Project	**IEEE 802.16 Broadband Wireless Access Working Group <http://ieee802.org/16>**
Title	**Clarification of AAS Private Map with H-ARQ Support**
Date Submitted	**2005-01-20**
Source(s)	Inseok Hwang ,Jaehee Cho, Seungjoo Maeng, Jaeho Jeon, Soonyoung Yoon, **Samsung Electronics Co. Ltd.** is91.hwang@samsung.com
Re:	Recirculation of IEEE 802.16maint-04/10
Abstract	Clarification of AAS private map with H-ARQ support is proposed.
Purpose	Adoption of the suggested changes
Notice	This document has been prepared to assist IEEE 802.16. It is offered as a basis for discussion and is not binding on the contributing individual(s) or organization(s). The material in this document is subject to change in form and content after further study. The contributor(s) reserve(s) the right to add, amend or withdraw material contained herein.
Release	The contributor grants a free, irrevocable license to the IEEE to incorporate material contained in this contribution, and any modifications thereof, in the creation of an IEEE Standards publication; to copyright in the IEEE's name any IEEE Standards publication even though it may include portions of this contribution; and at the IEEE's sole discretion t

Fig. 1. Reduced AAS Private MAP Operation

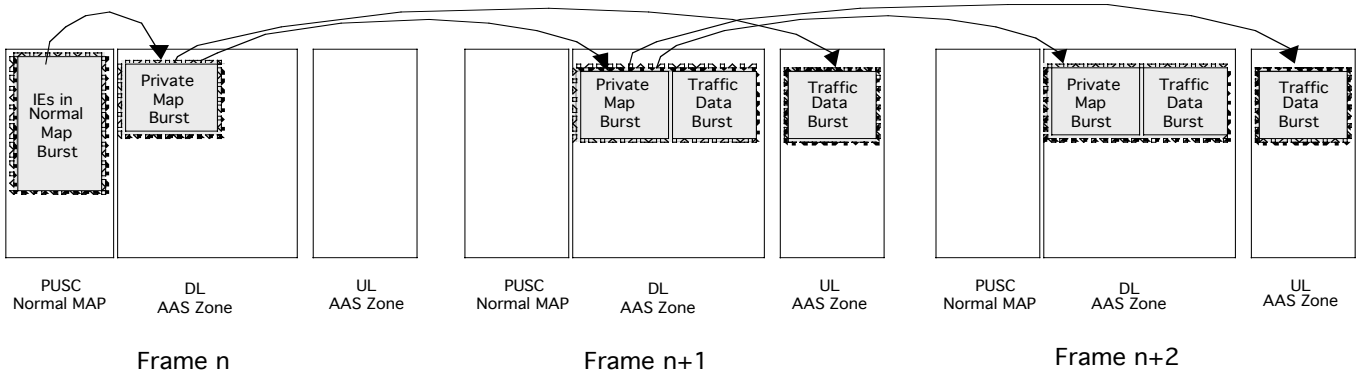
Fig. 1 illustrates the reduced AAS Private MAP operation when reduced AAS Private MAP points the allocation region for next frame. In the figure, dashed box denotes the absolute allocation region.

To enable separate modulation and coding, the following fields are added in Reduced_AAS_Private_DL_MAP message. Note that when 'Separate MCS Enabled', DL data burst a reduced_AAS_Private_MAP including all AAS configuration change information, bandwidth allocation, H-ARQ signaling information are encoded separately.

- 'Separate MCS Enabled' to indicate separate coding for reduced AAS Private Map and DL data burst
- 'Slot Duration' to specify number of slots for transmitting reduced AAS_Private_MAP
- 'DIUC and Repetition Coding Indication' for reduced AAS_Private_MAP

Since the reduced AAS_Private_DL_MAP specifies the two-dimensional region for reduced AAS_Private_MAP and DL data burst, the data burst are transmitted through the remaining slots after assigning slots for reduced AAS_Private_MAP.
